MEMORANDUM

To: Design Advisory Board
From: Scott Gustin
Re: 199 King Street
Date: May 23, 2023

File: ZP-23-162
Location: 199 King Street
Zone: RH **Ward:** 6S
Parking District: Neighborhood
Date application accepted: April 12, 2023, Complete May 5, 2023
Applicant/ Owner: Dan Goltzman / 199 King Street, LLC
Request: Proposed construction of new 6-unit apartment building on vacant lot.

SITE/UTILITY PLAN

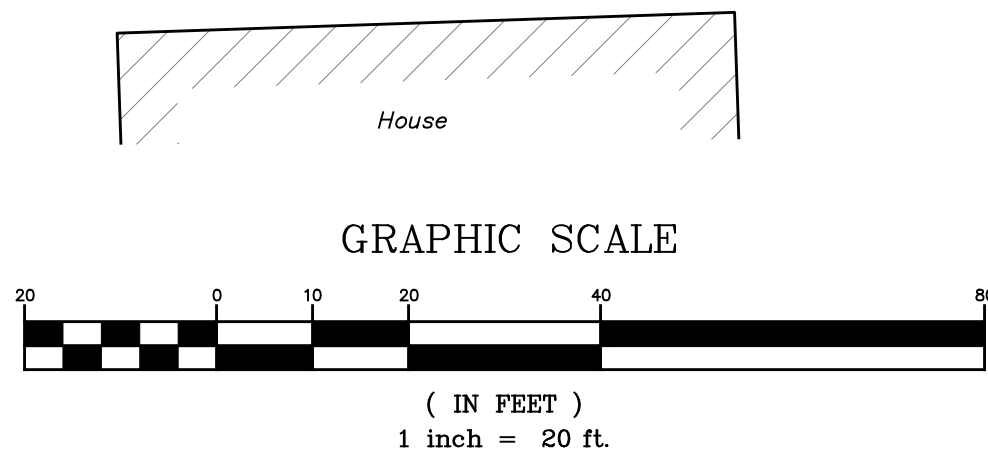
No new fencing or retaining walls are proposed. Some limited new landscaping is proposed within the green space abutting the new building. A perennial garden will run the length of the building's King Street frontage (the rendering depicts shrubs as well). A group of 3 arborvitae will flank the building's southwestern corner. One new serviceberry will probably be set at the northwestern corner; however, the site plan labels this new planting as 3 arborvitae and seems to be incorrect. Clarification of the site plan as to new plantings is needed.

1. Clarify the proposed site plan as to proposed landscaping.
2. Provide details as to the rooftop mechanical equipment screening, the trash / recycling enclosure, and mailbox location.
3. Bury utility lines serving the proposed building.

② Level 3
3/16" = 1'-0"

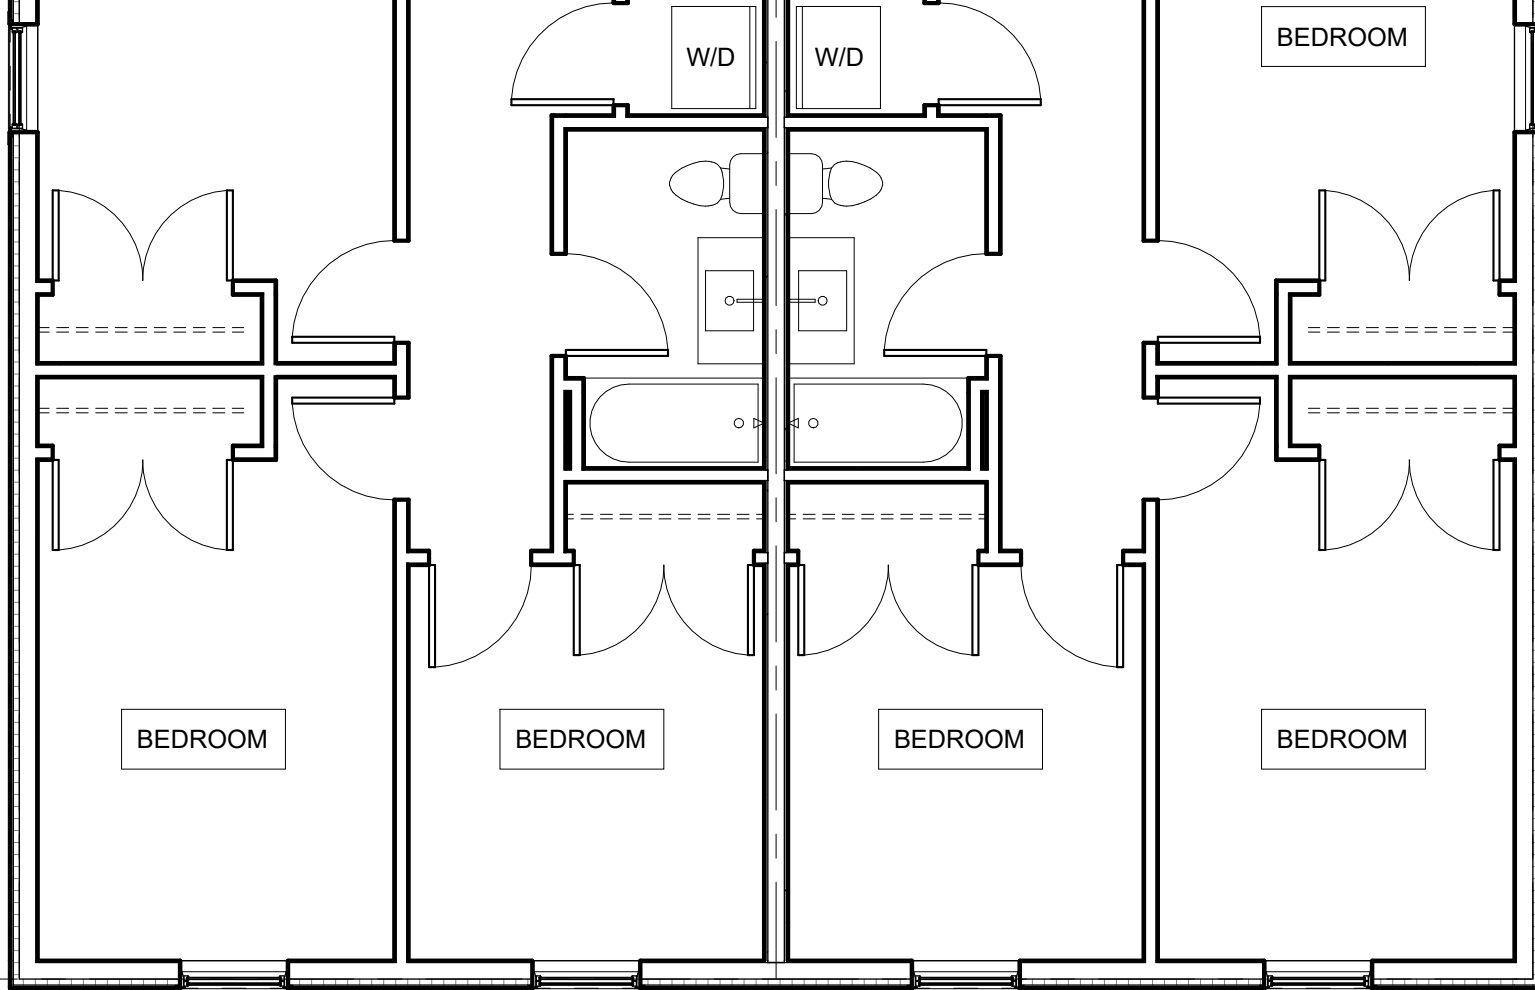
Rooftop mechanicals are depicted on the project plans and are appropriately located to the rear of the building. Screening is noted; however, details are not provided and must be.
